From: Patricia Harrell <Pat_Harrell@msn.com>
Sent: Friday, January 27, 2017 11:42 AM
To: Lindsey Ozbolt
Subject: Re: East Lake Sammamish Trail-South Sammamish Segment B section-60% Design Plan comments

Thank you for contacting the City of Sammamish regarding the current Shoreline Substantial Development Permit Application for East Lake Sammamish Trail Segment 2B (SSDP2016-00415).

RE: King County SSDP Permit-- South Sammamish Segment B
Homeowner comments regarding 60% Design Plan
Survey Station 332+00
2221 East Lake Sammamish PL SE

Comments and Concerns for Trail Master Plan Segment B (Sht AL6)

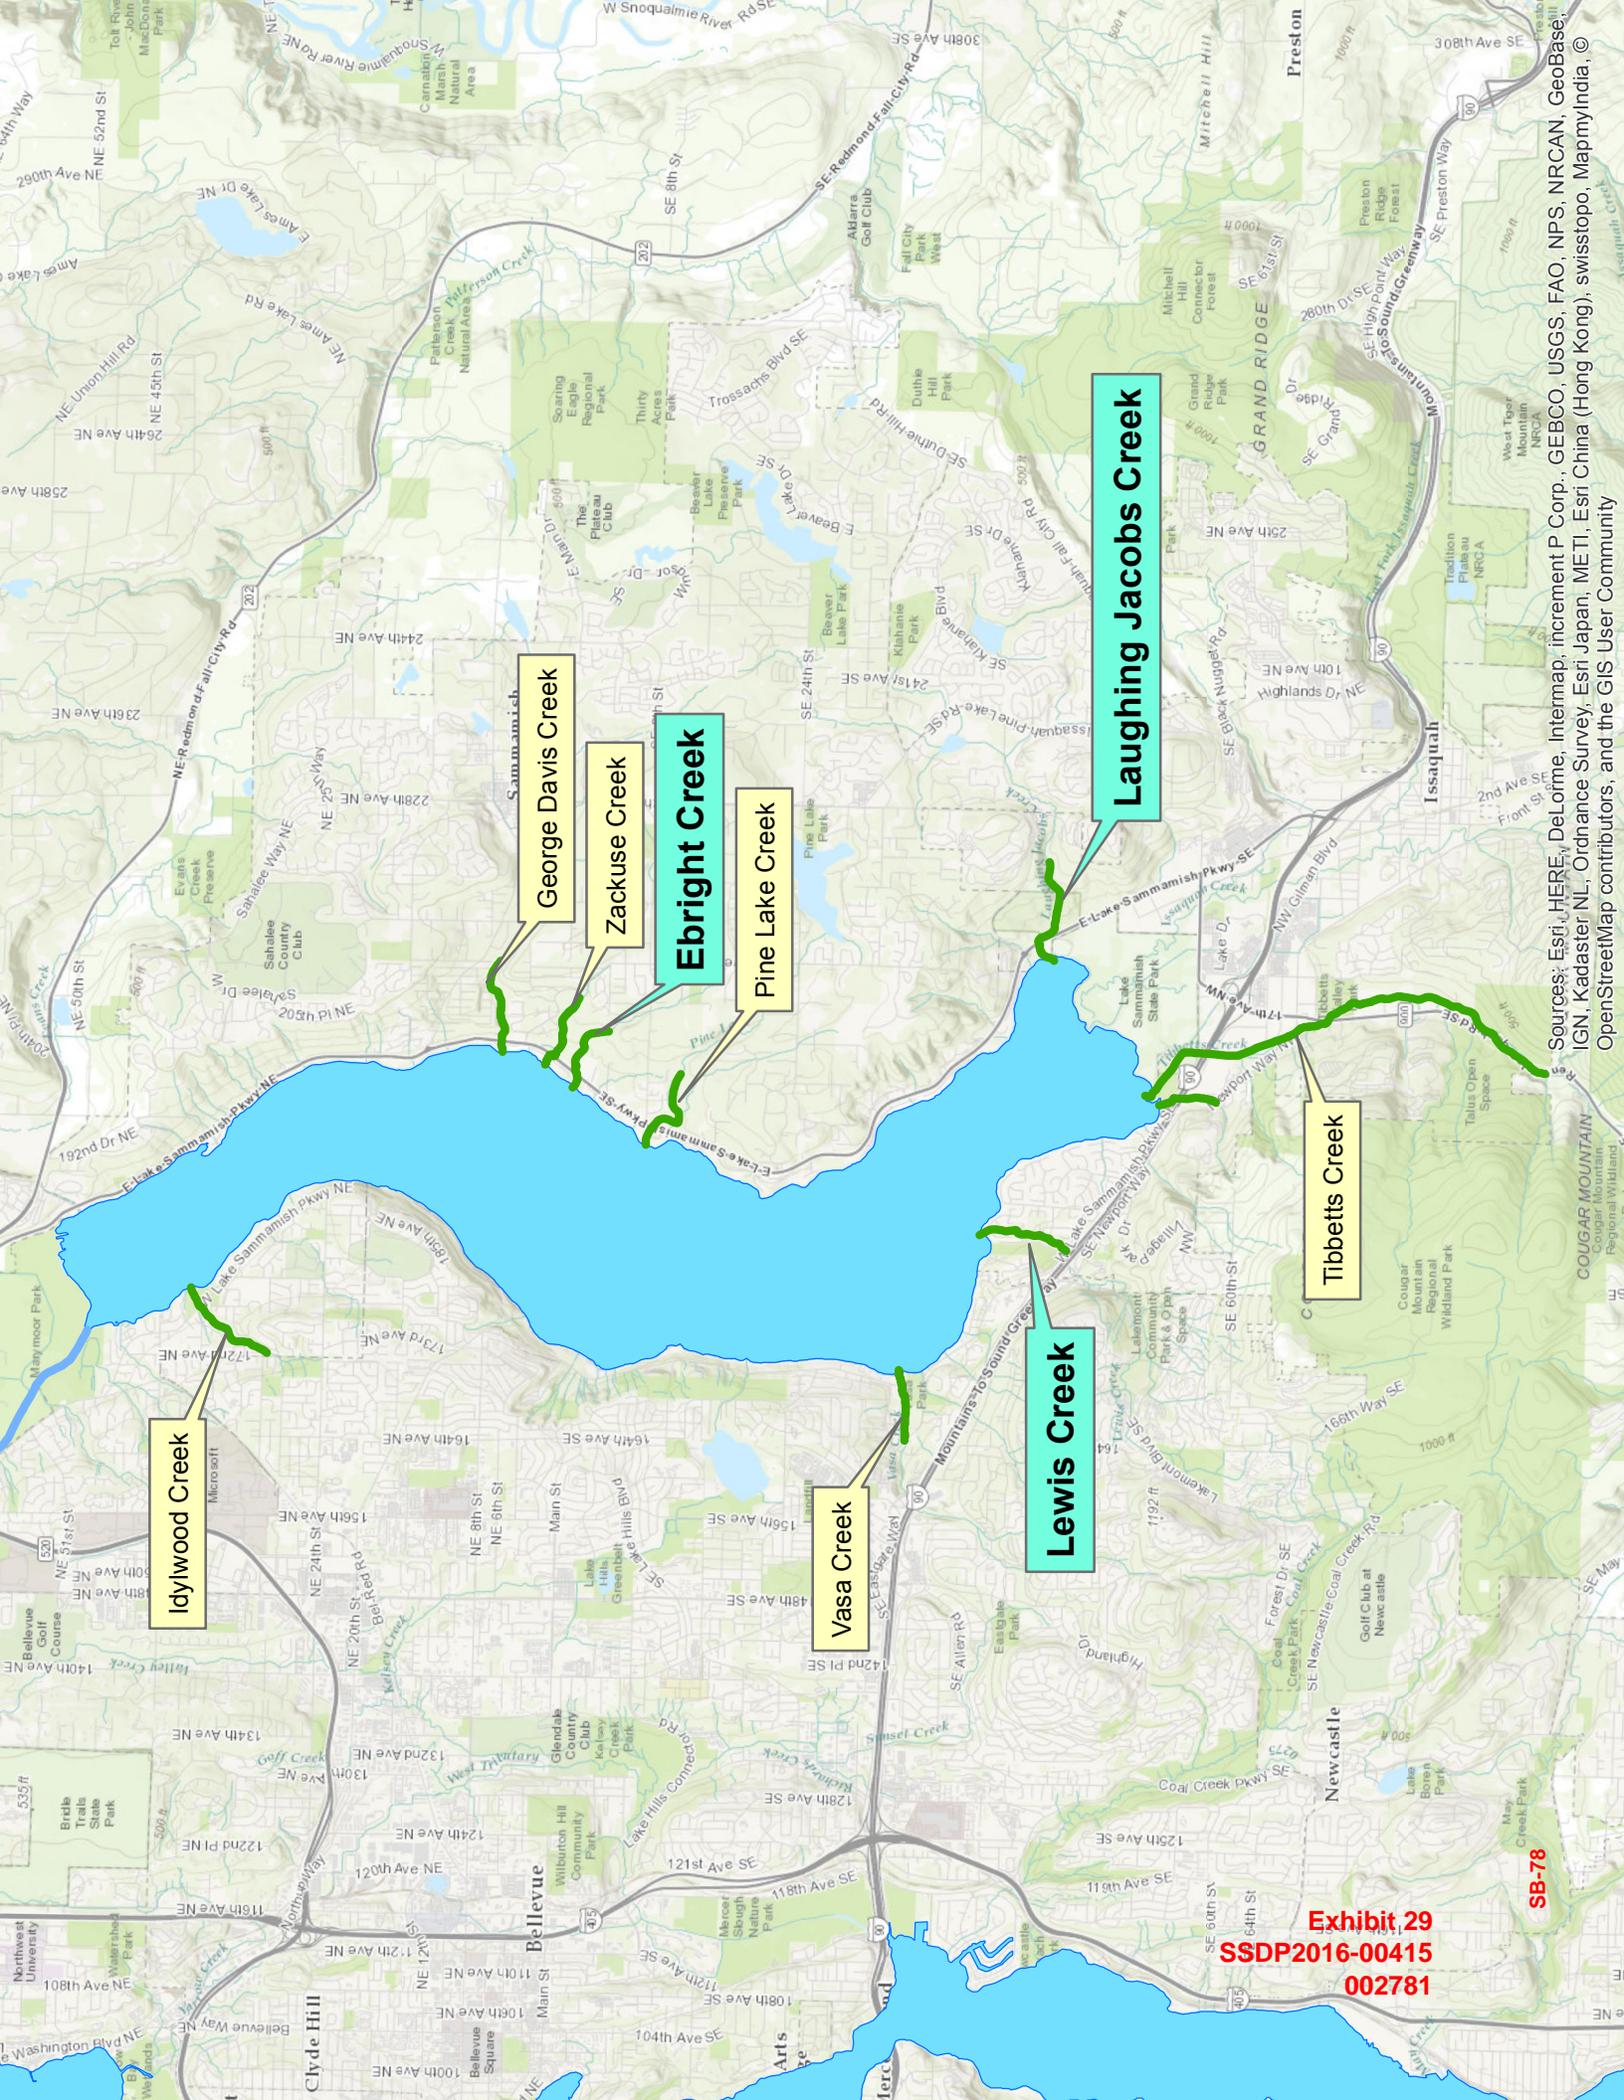
- c) Zackuse Creek Station 424+60 pg61 AL29 & pg81 FP5
 - d) George Davis Crk Station 441+40 pg65 AL33 & pg83 FP7
- and there may be other G, EX, or other pages with related info.
